To: Mayor Bruce Greenlee, Town of Bronson

From: Mark W. Thomas, PE

Date: March 16, 2026

RE: **Third-Party Review of ALT Analysis**
Kimley-Horn Project Number 242487000

Figure 2: Water Demand Projections

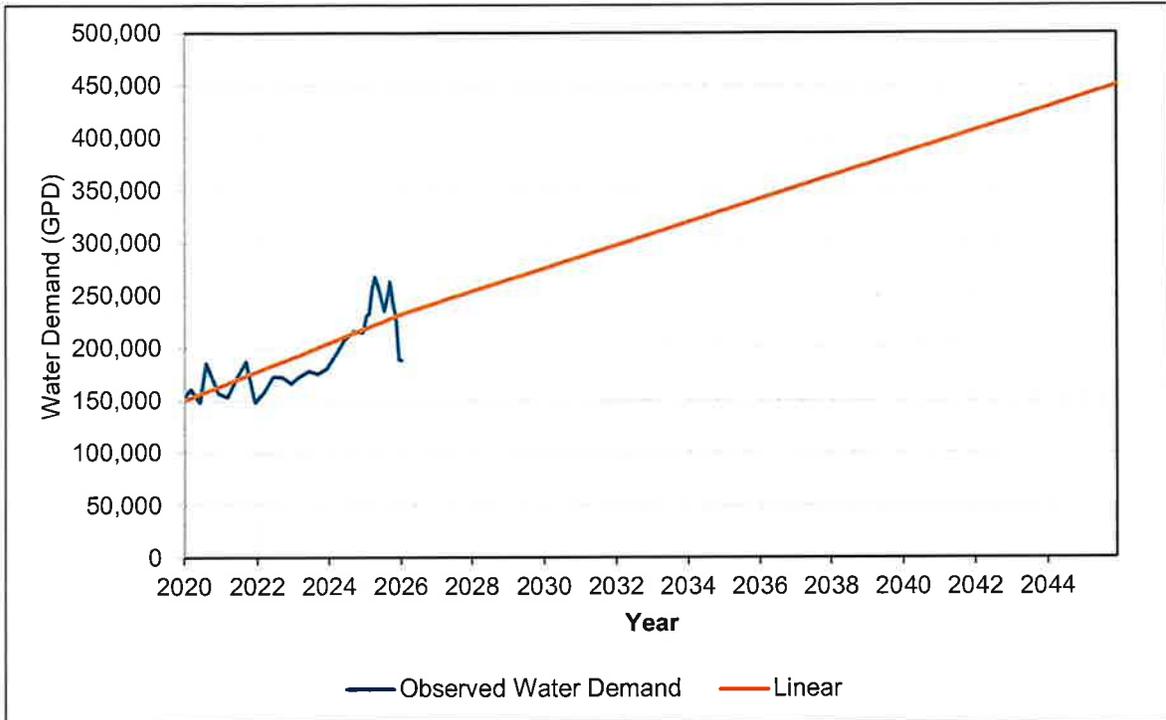
Kimley-Horn reviewed monthly operating reports (“MORs”) for January 2020 through February 2026. Reports were reviewed on a quarterly basis for 2020 through 2024 and a monthly basis for 2025 and early 2026. Kimley-Horn used reported water production to develop a linear projection model through 2045. This approach was taken because it is unclear how the Town plans to expand the area served by centralized water. The linear projection model achieves a reasonable fit with observed data. As shown in **Figure 2**, the projections indicate that potable water demand could approximately double from ±225,000 gallons per day (“GPD”) to ±450,000 GPD over the next 20 years. This is within the existing permitted capacity of the Bronson WTP and would not be expected to trigger a need for capacity expansion directly. Based on these projections, Kimley-Horn notes that the Town does not appear to need additional water treatment capacity over the next 20 years.

Figure 4: Wastewater Flow Projections

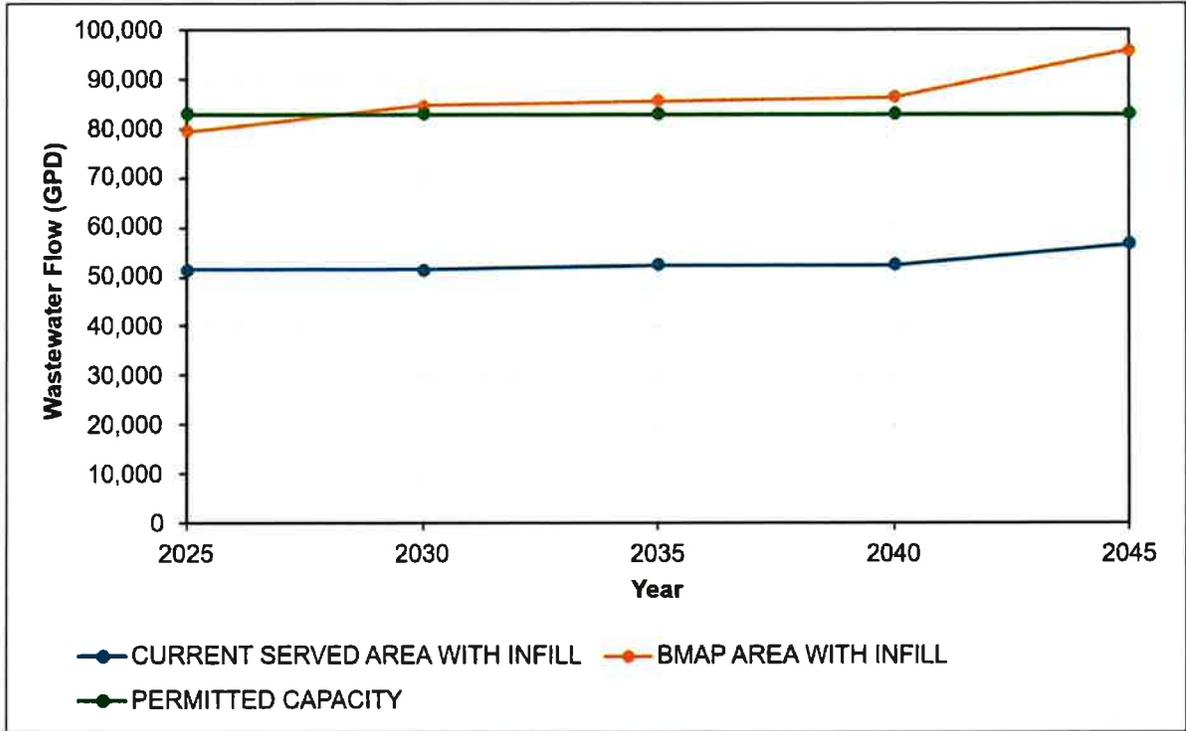
A portion of Bronson is within the Rainbow Springs BMAP, and it is required that parcels within that area be converted from septic to sewer or enhanced septic systems. Additionally, the current service area contains infill parcels that will contribute wastewater flow to the Town’s WWTF when they become occupied. The Southwest Florida Water Management District (“SWFWMD”) develops population projections and makes them publicly available via shapefiles, which include Levy County. Using the population projections for the existing served area, Kimley-Horn estimates a gross wastewater production rate of 65 GPD per capita (“GPDC”). Kimley-Horn prepared wastewater flow projections through 2045. The projections assume that vacant infill parcels within the currently served area will be connected upon development. With septic-to-sewer funding not guaranteed, it is unknown when parcels within the Rainbow Springs BMAP will connect to the Town’s collection system. **Figure 3** summarizes these flow projections. Projections indicate that converting the septic tanks that are within the Rainbow Springs BMAP area will result in wastewater flows that exceed the existing WWTF permitted capacity by approximately 15,000 GPD. It is likely that the plant could be rerated with minor improvements to accommodate flows from the Rainbow Springs BMAP area. However, the Town could support partial septic to sewer conversions within the Rainbow Springs BMAP area without WWTF improvements. The Town could seek grant funding for necessary WWTF improvements as part of full septic to sewer conversion in the Rainbow Springs BMAP area.

Flow projections indicate that the Bronson WWTF will exceed the existing permitted capacity by approximately 15,000 GPD with full septic-to-sewer conversion of the septic systems within the Rainbow Springs BMAP. However, septic to sewer conversion is dependent on grant funding with uncertain timing. Grant funds could be sought for WWTF improvements to accommodate additional flows from the Rainbow Springs BMAP area as future septic to sewer conversions are brought online. Because the timing of future septic to sewer conversions is unknown, current data shows there is no immediate need for expansion, as wastewater flows are not expected to exceed the Bronson WWTF capacity under present conditions. The
